Access Audit

St Michael's Primary School,
Penberthy Road, Helston TR13
8AR

Prepared on Behalf of
Celtic Cross Education (St Austell)

Date: 28th February 2022

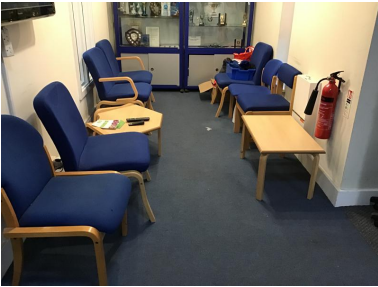
Photo	Item	Issues	Recommendations	P	£
	2.1.5.2	The plant pot obstructs manoeuvring space on the approach.	Relocate plant pot	1	Zero
	2.1.6	Year 5 entrance			
	2.1.6.1	The entrance door achieves a clear width of 900mm which exceeds current best practice standards so should be sufficient for all.			
	2.2	Reception			
	2.2.1	The reception is generally well designed.			
		The desk is appropriately located in relation to the entrance and identified by clear signage on the approach.			
		The reception desk incorporates an adequate low level position and writing surface for a wheelchair user.

2.5.2	Year 6 toilets

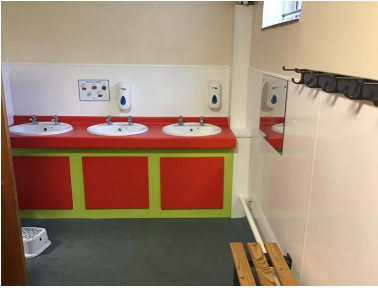
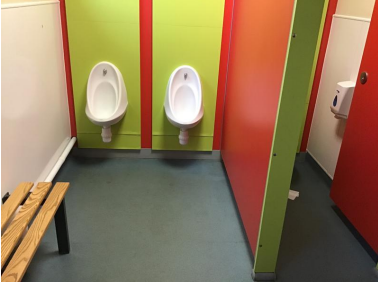
Photo	Item	Issues	Recommendations	P	£
	2.5.2.1	<p>The toilets are generally well designed. The lighting levels are adequate.</p> <p>The toilets are fitted with ergonomic brassware and fittings which will be easy to use by all.</p> <p>The sanitaryware and brassware achieve adequate colour and contrast against adjacent surfaces.</p>			
	2.5.3	Year 3 toilets			
	2.5.3.1	<p>The toilets are generally well designed. The lighting levels are adequate.</p> <p>The toilets are fitted with ergonomic brassware and fittings which will be easy to use by all.</p> <p>The sanitaryware and brassware achieve adequate colour and contrast against adjacent surfaces.</p>			
	2.5.4	Year 4 toilets

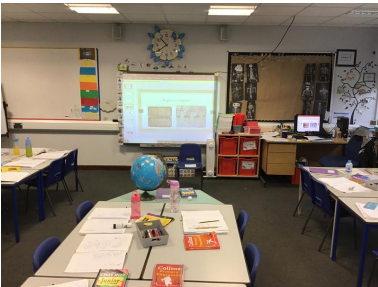
Photo	Item	Issues	Recommendations	P	£
	2.11.2	<p>Basins in the classrooms are fitted with knob type taps which will be difficult to grip and turn by someone with impaired dexterity to the hands.</p> <p>We recommend that all knob taps are replaced with lever type taps as part of ongoing maintenance /refurbishment or when a specific need is identified.</p> <p>As a minimum taps to accessible workstations should be fitted with lever type controls.</p>	Replace knob type taps with lever type taps	3R / 4	A

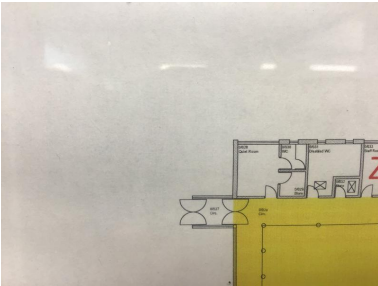
Photo	Item	Issues	Recommendations	P	£
	3.5.4.3	<p>The sanitaryware and fittings are poorly contrasted making them difficult to identify by a visually impaired user.</p> <p>This should be addressed when next refurbishing this area.</p>	<p>Improve contrast of sanitaryware and fittings</p>	3R	Zero

3.5.4.4	<p>The staff toilets are currently accessed directly from the Woodland 1-2-1 teaching and medical room.</p> <p>We do not consider this arrangement appropriate. We recommend that the staff toilets are relocated.</p> <p>By converting the adjacent store access to staff toilets could be provided from the entrance area and main hall.</p>	<p>Relocate staff toilets</p>	2	D

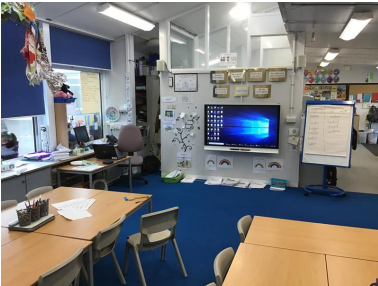
Photo	Item	Issues	Recommendations	P	£
	3.8.2	<p>Lighting levels in the classrooms are generally adequate with lux levels at the desk surface of 600lux which exceeds current best practice.</p>			
	3.8.3	<p>Given the size of the classrooms it may prove difficult for a hearing aid user to listen to or hear a teacher or speaker.</p> <p>We recommend a fixed hearing loop is fitted to aid communication with hearing aid users. Teaching staff should be trained in its use and pictogram signage fitted to identify the loop.</p> <p>It would be appropriate to address this issue reactively when a specific need is identified.</p>	Fit hearing loop to classrooms	4	A
	3.9	Signage and Wayfinding			
	3.9.1	<p>The school has limited internal wayfinding signage.</p> <p>This reflects the staff and pupils familiarity with the layout of the school. Visitors to the school are accompanied by staff.</p>
